Source: TSG CN WG 1
Title: CRs to R97 (with mirror CRs) on Work Item GPRS towards 09.18
Agenda item: 7.12
Document for: APPROVAL

This document contains 6 CRs on R97 (with mirror CRs) to Work Item "GPRS", that have been agreed by TSG CN WG1, and are forwarded to TSG CN Plenary meeting #14 for approval.

⌘ **09.18 CR A046** ⌘ ev **-** ⌘ Current version: **6.6.0** ⌘

| Title: | ⌘ Clarification of the periodic routing area update procedure | | |

Figure 4.2/GSM 09.18: State diagram at the SGSN

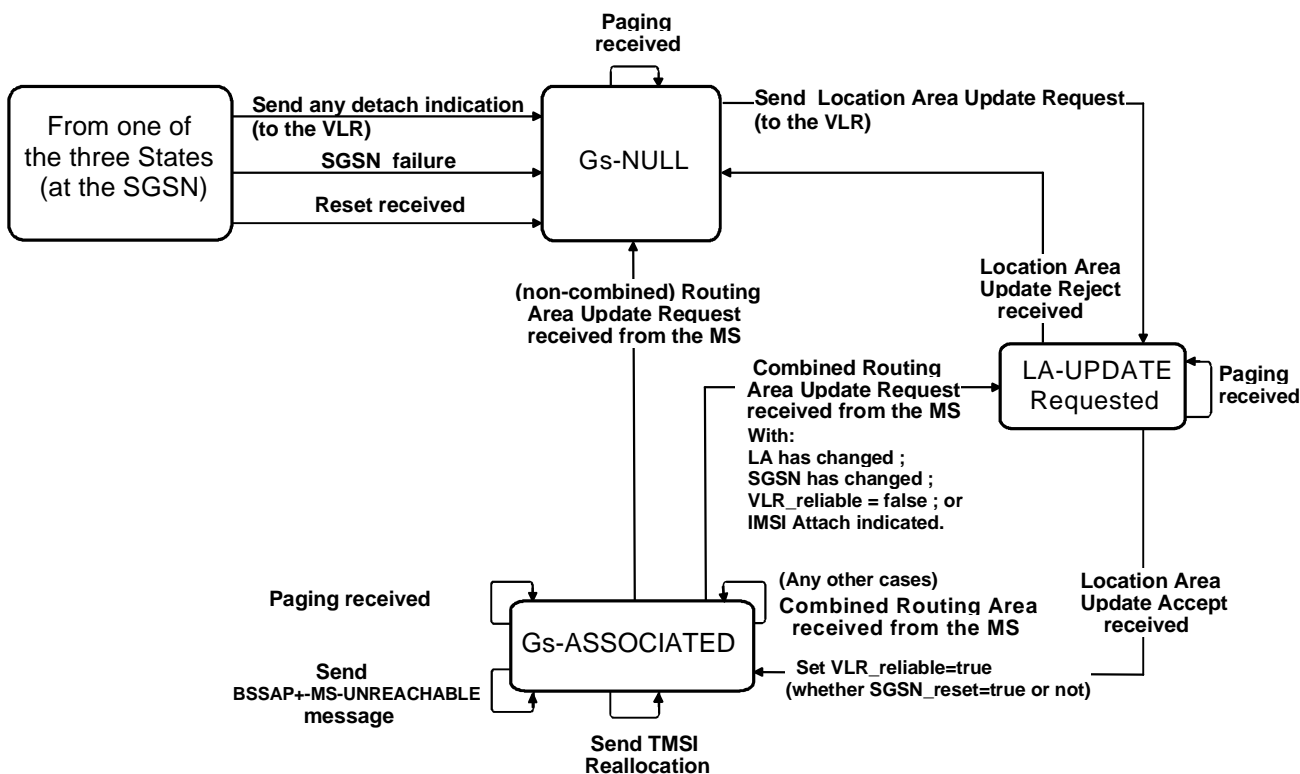
| Reason for change: | ⌘ The current description of the periodic routing area update is incomplete, as neither the description of the states at the SGSN (subclause 4.2.2) nor the procedural description (subclause 6.1) specify what happens with the state of the association in the SGSN. |

| Summary of change: | ⌘ It is clarified that the state of the association in the SGSN is not changed. |

Figure 4.2/3GPP TS 29.018: State diagram at the SGSN

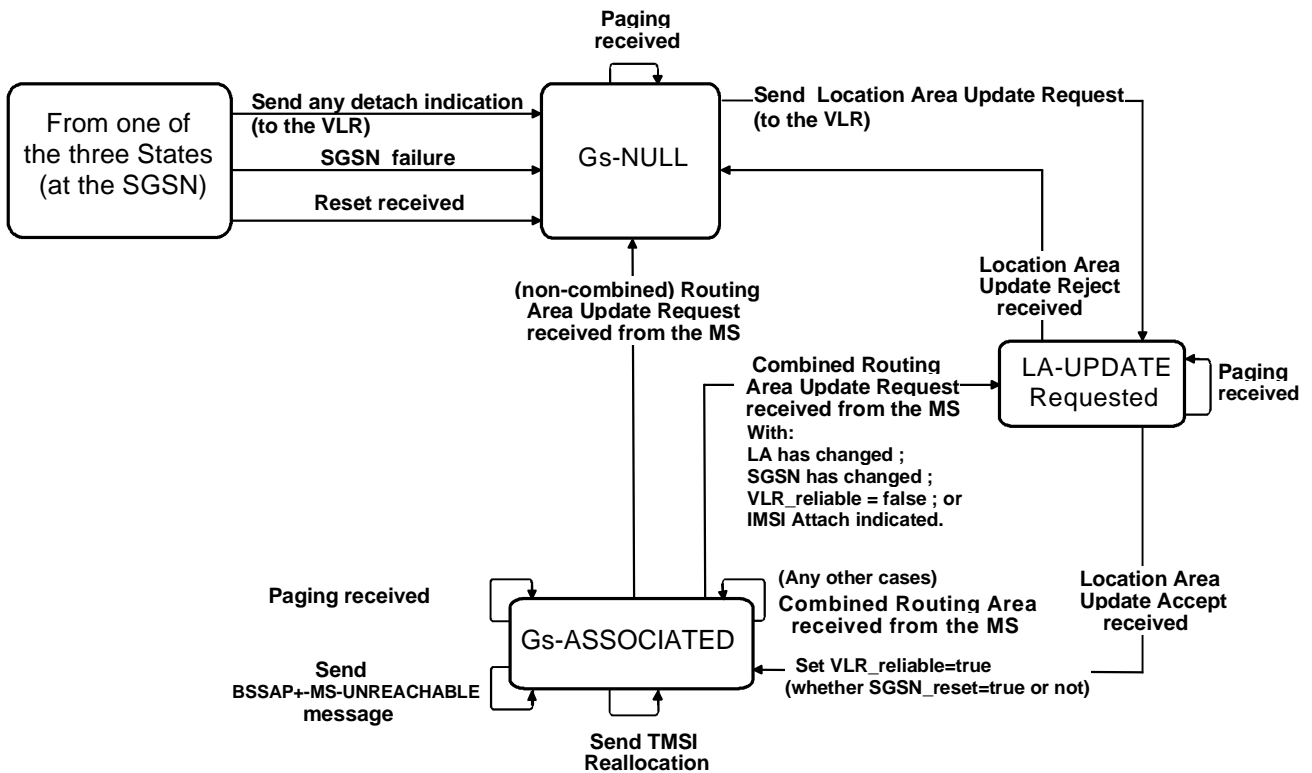
| Reason for change: | ⌘ The current description of the periodic routing area update is incomplete, as neither the description of the states at the SGSN (subclause 4.2.2) nor the procedural description (subclause 6.1) specify what happens with the state of the association in the SGSN. |

| Summary of change: | ⌘ It is clarified that the state of the association in the SGSN is not changed. |
